Subject: Design Modification Request

Reference: OBC2001 – Brookman Place Subdivision (Olivia Beach, LLC)

Location: 17687 SW Brookman Road

PRELIMINARY SITE PLAN EXHIBIT #1

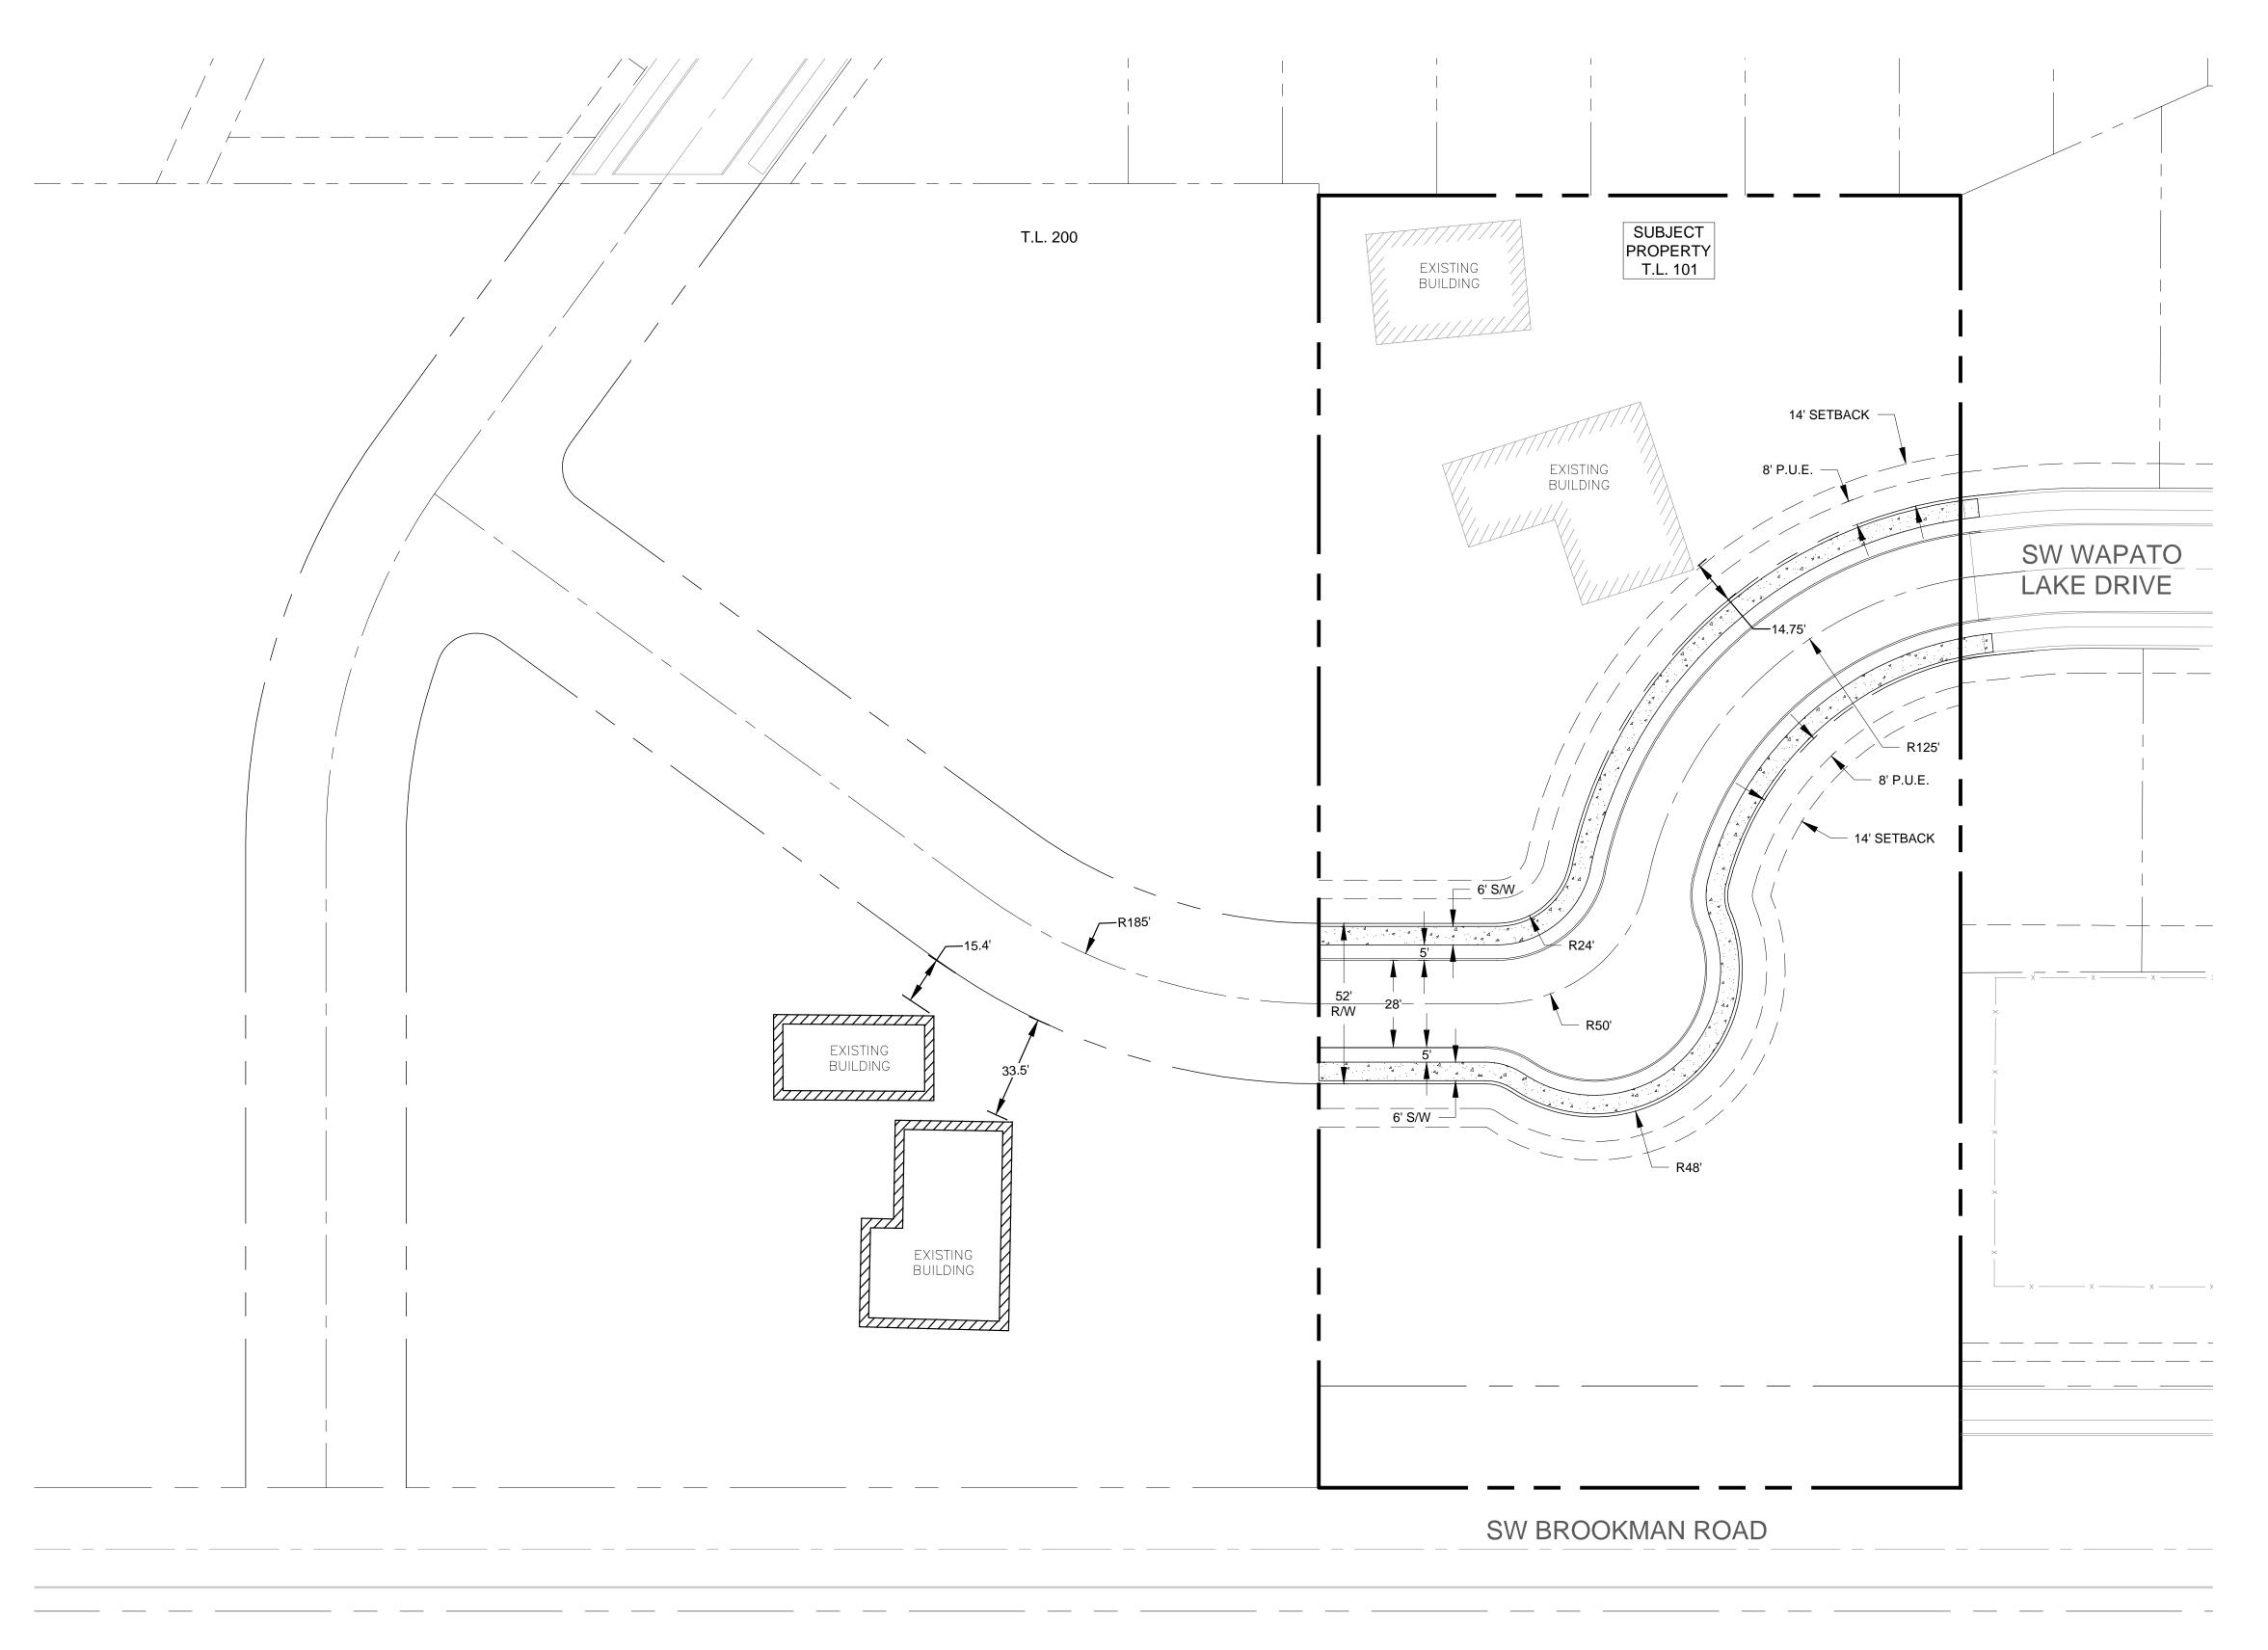
Reece & Associates, Inc., is requesting that a minimum horizontal curve radius of 125 feet be used for a street with a -2.5 percent cross slope, instead of the 185-foot minimum standard.

The proposed minimum horizontal curve radius will be modified to 125 feet for a street with a -2.5 percent cross slope. This design modification request will affect approximately 153 feet of the eastern portion of the street extension.

Due to the location of the existing dwelling, reducing the minimum horizontal curve radius to 125 feet would ensure compliance with the front setback and public utility easement requirements. It would also allow for the preservation of the adjacent dwelling when SW Wapato Lake Drive is extended through the abutting property.

Digitally signed by Craig Christensen, P.E. Date: 2021.10.13 09:59:58 -07'00' The 125-foot centerline requested exceeds a 20mph roadway speed.

Conditions: Curve and speed signage shall be installed in advance of the reduced speed curves. No parking will be allowed on either side of the street in the location of a substandard street curve.

Note: Approval of this design exception is for reducing the curve radius only and does not guarantee approval of the layout attached.

PRELIMINARY SITE PLAN
EXHIBIT #2
OLIVIA BEACH, LLC
SHERWOOD, OREGON

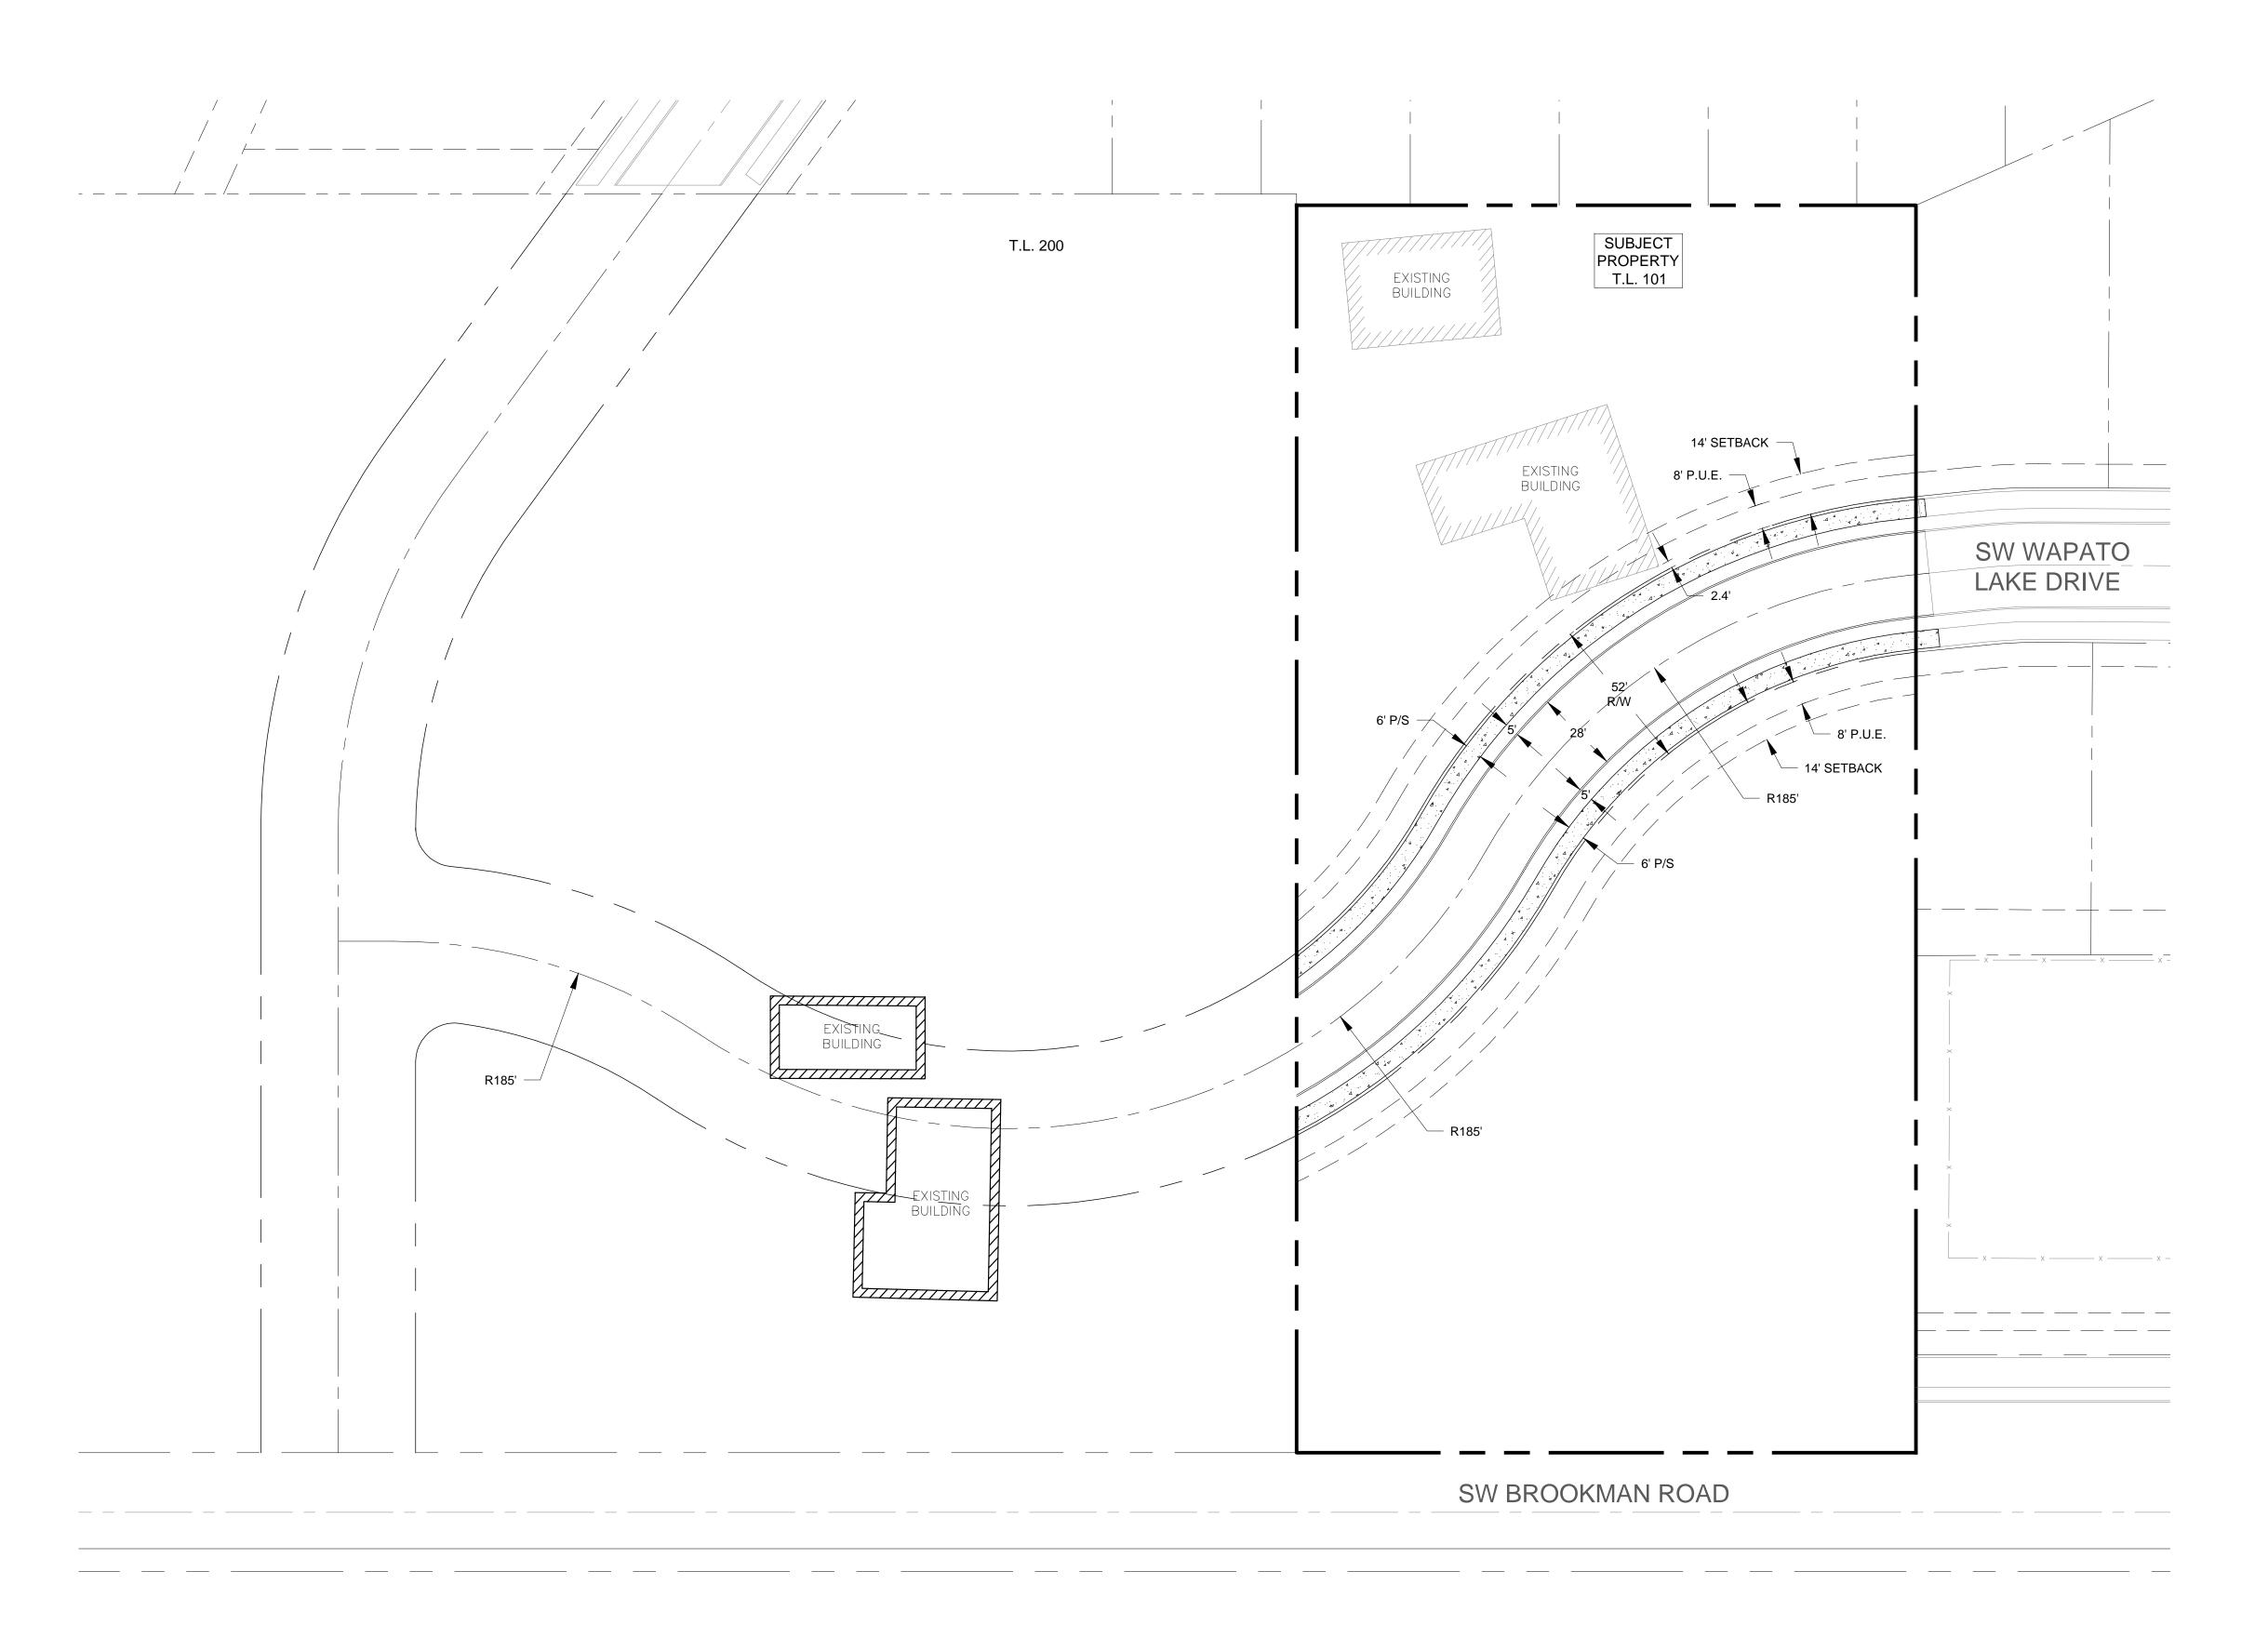
If the proposed street extension complies with the 185-foot minimum horizontal curve radius, it would be constructed approximately 2.4 feet from the existing dwelling. As a result, the dwelling would not comply with the applicable front yard setback for the Medium Density Residential High zoning district and an eight-foot-wide public utility easement could not be provided along the north side of the street extension.

Additionally, compliance with this standard will complicate future street extension. If the road is continued using the 185-foot radius, it is unlikely the adjacent property could extend the street without demolishing the existing home. Please see Exhibit #2, attached, for an illustration of a potential street design that complies with this standard.
